Maule Aircraft Corporation

SERVICE BULLETIN #2

Subject: Rudder Bar Assembly.

Models Affected: All M-4 and M-5 Series Aircraft.

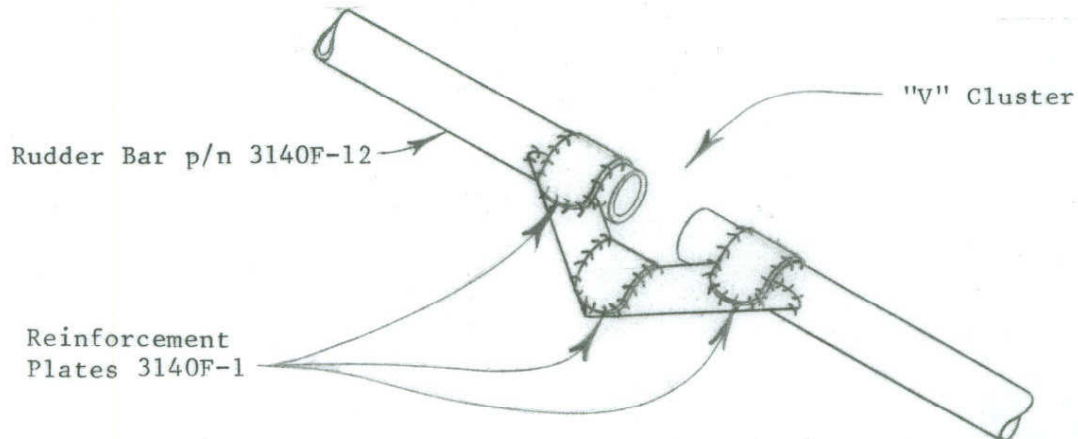
Background: There is a possibility that the horizontal tubes of the
rudder bar may be cracked or may become cracked where "V" cluster
attaches.

- c. Locate and weld reinforcement plates p/n 3140F-1 as shown in sketch:

- 3 ea. reinforcement plates (p/n 3140F-1).
